## **AHEPA 310-VII SUBDIVISION,** **RESUBDIVISION OF LOT 1**

APPLICATION NUMBER 7 DATE May 1, 2014  
APPLICANT Ahepa 310-V11 Subdivision, Resubdivision Of Lot 1  
REQUEST Subdivision

# DETAIL SITE PLAN

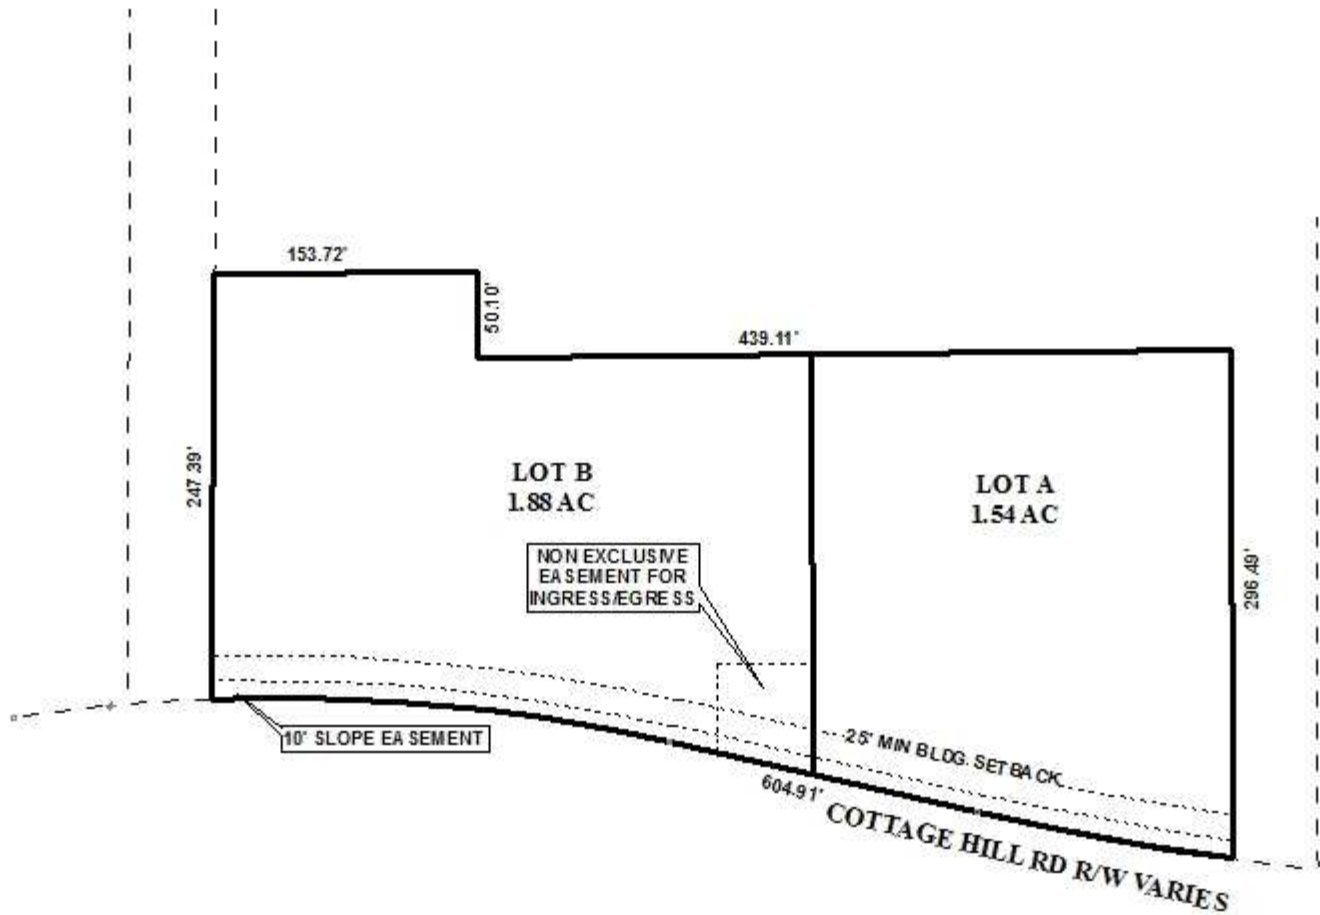
The site fronts Cottage Hill Road, a major street, which should have a right-of-way of 100' to be in compliance with the Major Street Plan. The preliminary plat states that the right-of-way varies. The 1997 application required the dedication sufficient to provide a 40-foot service road, however, it appears that the dedication was never undertaken. Since 1997, the Major Street Plan has been amended to no longer require service roads; however, dedication to provide 50' from the centerline may be necessary.

The previously approved Subdivision limited the subject lot to two (2) curb cuts with the size, location and design of all curb cuts is to be approved by Traffic Engineering and conform to AASHTO standards. The preliminary plat illustrates a 55' wide non-exclusive easement for ingress and egress, indicating that the lots intend to share a single curb cut. If this is the case, it should be noted that a Planned Unit Development will be required to allow shared access between two building sites.

The preliminary plat illustrates the 25' minimum building setback line required in Section V.D.9. If approved, the minimum building setback line should be retained on the Final Plat as well, and reflect any required dedication.

The preliminary plat indicates a 10' telephone and non-exclusive slope easement along the front property line. A note should be placed on the Final Plat, if approved, stating that no structures shall be constructed in any easement.

- 1) dedication to provide 50' from the centerline of Cottage Hill Road, if necessary;
- 2) retention of the 25' minimum building setback line, adjusted for any required dedication;

- 3) retention of the lot size in square feet and acres;
- 4) placement of a note stating the development is limited to one shared curb-cut with the size, location and design of all curb cuts is to be approved by Traffic Engineering and conform to AASHTO standards subject to an approved Planned Unit Development;

- 5) placement of a note that no structures shall be constructed in any easement;
- 6) compliance with Engineering comments (*The following comments should be addressed prior to acceptance and signature by the City Engineer: A. Add a note to the SUBDIVISION PLAT stating that a Land Disturbance permit will be required for any land disturbing activity in accordance with the of the Storm Water Management and Flood Control Ordinance (Mobile City Code, Chapter 17 , Ordinance #65-007 & #65-045), latest edition. B. Add a note to the Plat stating that the approval of all applicable federal, state, and local agencies (including all storm water runoff, wetland and floodplain requirements) will be required prior to the issuance of a Land Disturbance permit. C. Add a note that sidewalk is required to be constructed along the frontage of each lot, or parcel, at time of development, unless a sidewalk waiver is approved. D.*
